Re: **Corrected** [REDACTED] Submission to Amendment C234 Cardinia Planning Scheme
PPTY: 10,11 and 14 – [REDACTED]

**Re: Amendment C234 Cardinia Planning Scheme
Pakenham East Precinct
Submission by [REDACTED]**

Pakenham East PSP – Preliminary Drainage Advice

Figure 1-1 – Typical Deep Creek Cross-Section Upstream of Princes Highway (Source: Stormy Water Solutions)

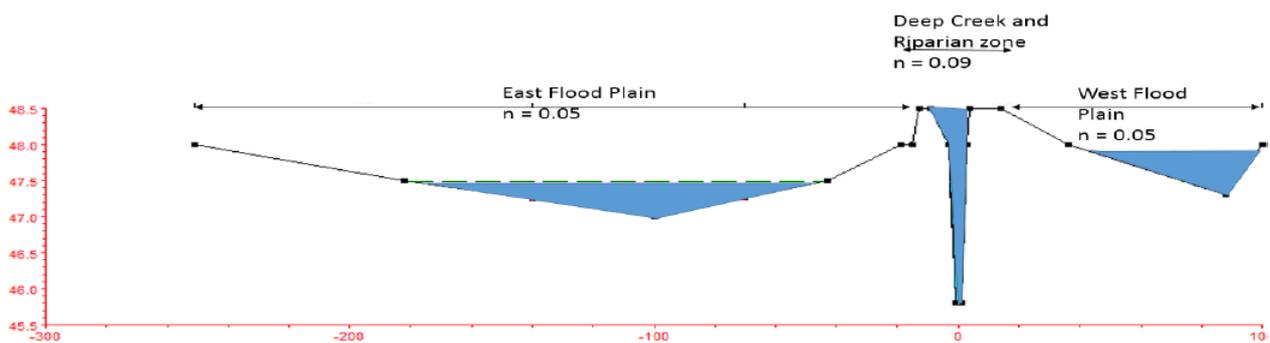
Melbourne Water has advised that the corridor is greater than the above setback to accommodate the entire 1% AEP flood extent. This is a reasonable position to take and is consistent with the guidelines above. However, the Deep Creek waterway and floodplain is highly modified. This is evident from the limited extent of riparian vegetation along the creek (Native Vegetation Precinct Plan, Ecology & Heritage Partners, Dec 2017) and low-lying pasture prevalent across its floodplain (Pakenham East Precinct Landscape Assessment, Hansen, May 2013) and a lack of connectivity between its main channel and floodplain (Deep Creek Corridor Proposals, Stormy Water Solutions, October 2014), as shown in Figure 1-1.

As currently detailed in the Native Vegetation Precinct Plan (Ecology & Heritage Partners, Dec 2017), the vegetation to be retained within the proposed 100 m corridor is limited to the existing riparian zone. This suggests that the proposed waterway corridor does not need to match the current 1% AEP extent to meet floodplain or environmental management best practice objectives. Importantly, Stormy Water Solutions’ report states that “once flow leaves Deep Creek [...] it cannot re-enter the creek”. Any waterway corridor would need

It is considered that a 50 m corridor is likely to be sufficient, as this is what has been allowed for at the downstream end of Deep Creek within the PSP (where 1% AEP flows would be greater than on the Subject Land). It may therefore be possible to reduce the waterway corridor to 50 m, as is currently proposed near Canty Lane. It is noted that a 50 m easement either side of the creek was considered sufficient for the approval of the 1990's low density subdivision located on the western side of Deep Creek downstream of the Princes Highway.

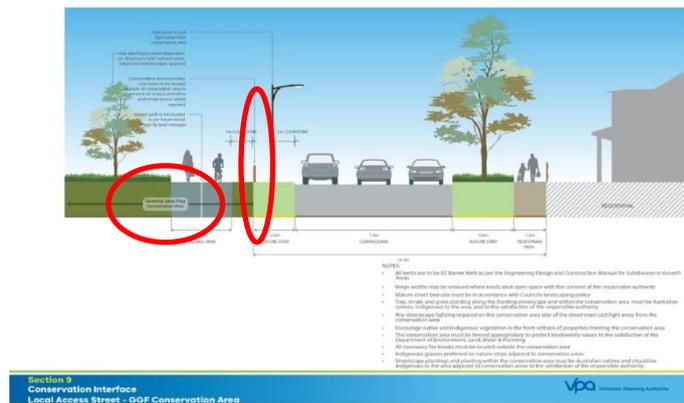
R54 Development within any Conservation Area (other than Conservation AreaLocal) must be in accordance with the relevant Conservation Area Concept Plan (Figure 6 - Deep Creek Conservation Reserve Concept Plan). **R55** Development abutting the Deep Creek Conservation Reserve must be in accordance with the corresponding relevant Interface Cross Section in **Appendix C: Road Cross Sections**, to the satisfaction of the Department of Environment, Land, Water and Planning, and the responsible authority.

Is this another name for the drainage reserve (100m) that runs along deep Creeks eastern bank ?

As Ecology and Partners 2018 report (page 7) states “frogs no longer occur in the study area”, the requirements of R54 and R55 need to be amended as does **Section 9**. If the fence requirement remains within Section 9 then it should be at the full cost of the authority that will manage the said reserve, or added to the

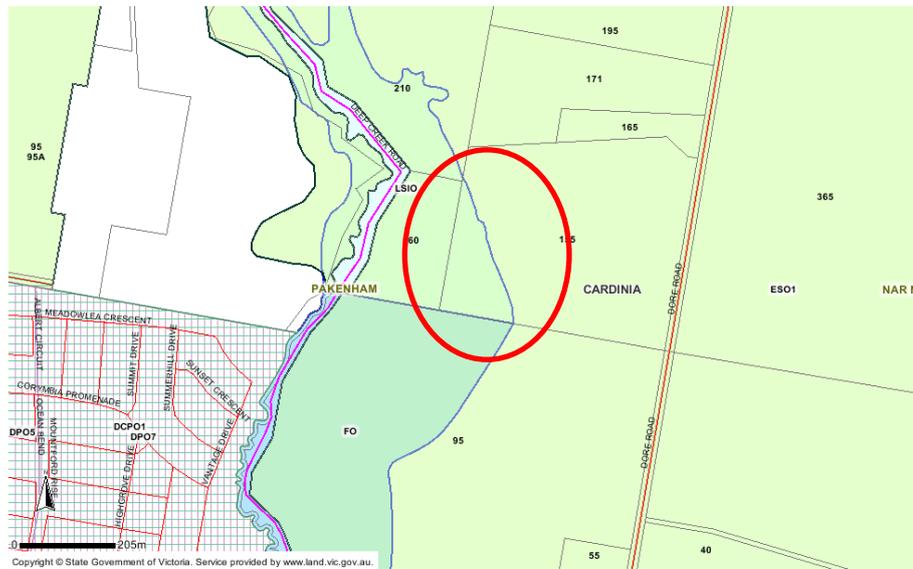
a) Why has the LSIO that affects 155 Dore Rd (Property No 1) been removed? (Fig 1 – Transmission Easement concept)

Having farmed and lived on this parcel of land for 116 years, the [REDACTED] strongly believe that the flood overlay was never correctly mapped. The background reports have some of the overland flow completely incorrect due to topography of our property (in that water cannot run up hill). These errors affect some of the data fed into the models that have been prepared by Stormy Water Solutions.

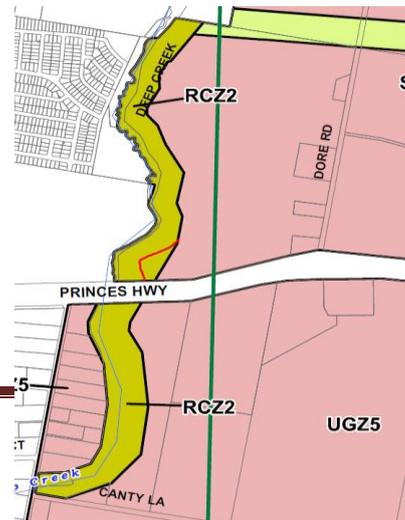
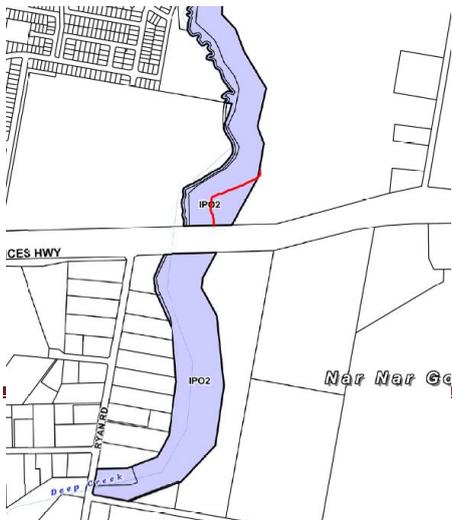
b) **RCZ2** and **IPO2** do not follow the 100m setback from the creek and need to be correctly aligned or reduced. (see red line)

Can the lines be corrected to follow the correct offset from the Creek?
